Subject: **Plan Modification: Clause 20A error correction to Auckland Unitary Plan (Operative in Part 2016)**

I seek your approval pursuant to clause 20A, schedule 1, Resource Management Act 1991 to correct three minor errors to the boundary of Designation 1853 Airport to Botany Bus Rapid Transit Rongomai Park to Puhinui Station (in the vicinity of Plunket Avenue).

Designation 1853 - Airport to Botany Bus Rapid Transit Rongomai to Puhinui Station (in the vicinity of Plunket Avenue)

Attachment 2
Designation 1853 Airport to Botany Bus Rapid Transit
Rongomai Park to Puhinui Station
AUP GIS Viewer (Before/After)

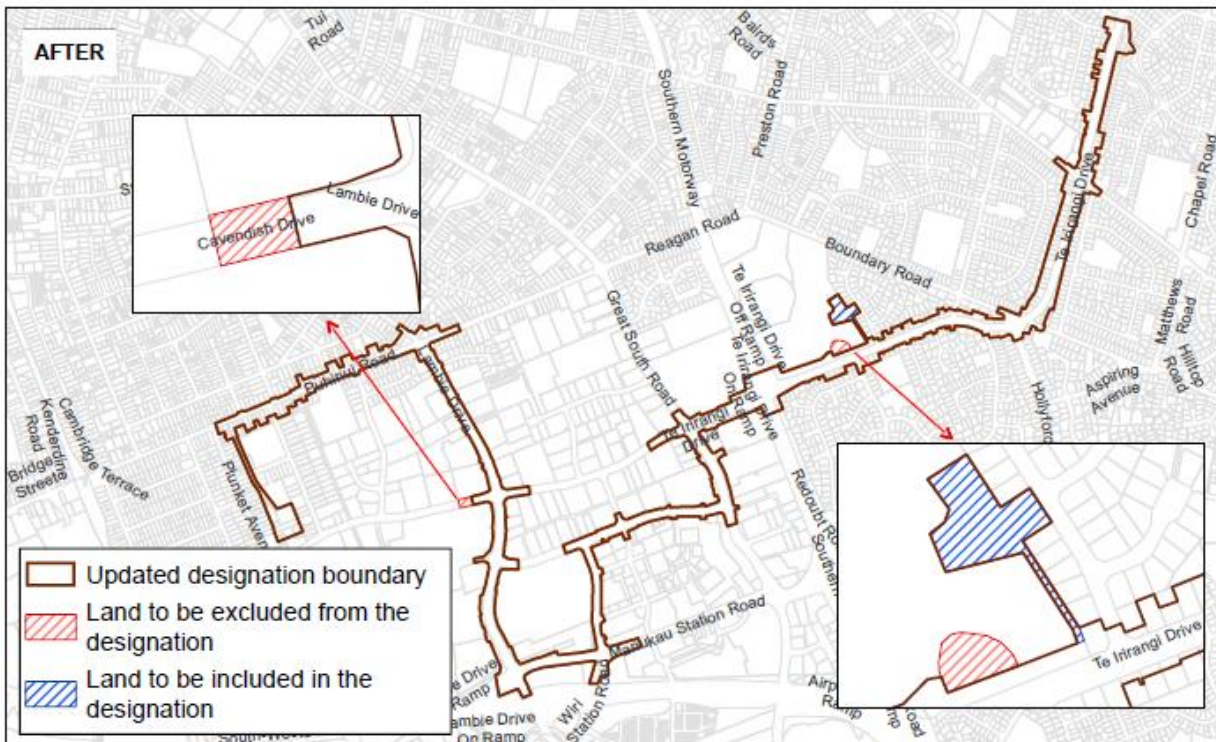
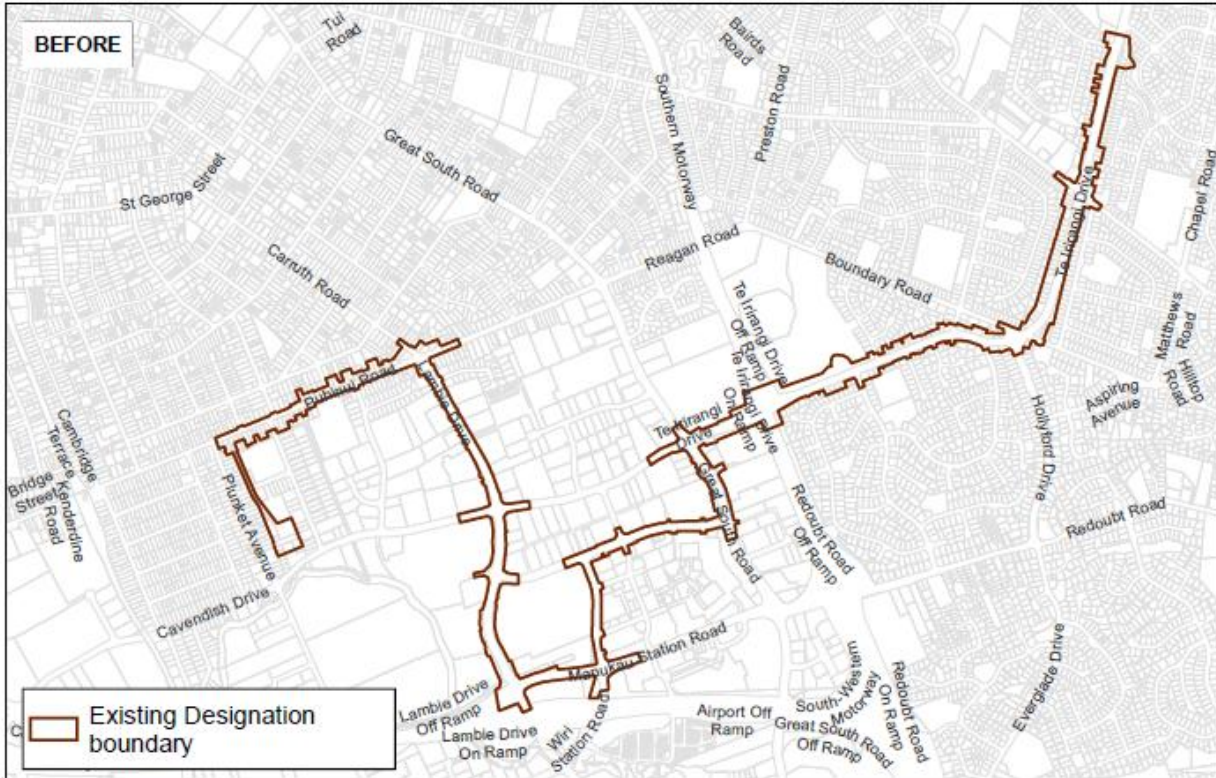
Provision in AUP	Amend Auckland Unitary Plan (Operative in Part) (AUP) GIS Viewer map: <ul style="list-style-type: none"> Designation 1853 Airport to Botany Bus Rapid Transit Rongomai Park to Puhinui Station (in the vicinity of Plunket Avenue).
Subject site and legal description (if applicable)	To correct the boundary of Designation 1853 Airport to Botany Bus Rapid Transit Rongomai Park to Puhinui Station (in the vicinity of Plunket Avenue).
Nature of error	<p>An email dated 12 February 2026, was received from Auckland Transport (refer Attachment 1). Auckland Transport has found that the boundary of the designation is not mapped correctly and does not align with the decision version of the Notice of Requirement for the designation.</p> <p>A map amendment is required to correct three minor errors in the designation boundary in the AUP. The errors were the result of inaccurate geospatial shapefiles being provided by Auckland Transport.</p> <p>Discussion</p> <p>Designation 1853 was confirmed in the AUP on 14 November 2025. Auckland Transport has advised that the designation boundary is incorrectly mapped and needs to be amended in the AUP – Management Layers - Designations.</p> <p>The 'Before' Map (refer Attachment 2) shows the boundary of the designation as it is currently mapped in the AUP. The 'After' Map (refer Attachment 2) shows the areas of land that need to be included and excluded from the designation boundary.</p>

<ul style="list-style-type: none"> neutral (they would not affect the rights of members of the public). <p>The change ensures the designation boundary is accurately shown on the AUP GIS Viewer map.</p>
Changes required to be made (text and/or in-text diagrams)	N/A
Changes required to be made (AUP or HGI maps)	Amend the boundary of Designation 1853 Airport to Botany Bus Rapid Transit Rongomai Park to Puhinui Station (in the vicinity of Plunket Avenue) in the AUP Management Layers - Designations. Refer Attachment 2 .
Attachments	<p>Attachment 1: Email request from Auckland Transport dated 12 February 2026.</p> <p>Attachment 2: Designation 1853 Airport to Botany Bus Rapid Transit Rongomai Park to Puhinui Station in the AUP GIS Viewer map (Before/After).</p>
<p>Maps prepared by: Danica Torres Geospatial Specialist</p>	<p>Text Entered by: N/A Planning Technician</p>
<p>Signature: </p>	<p>Signature:</p>
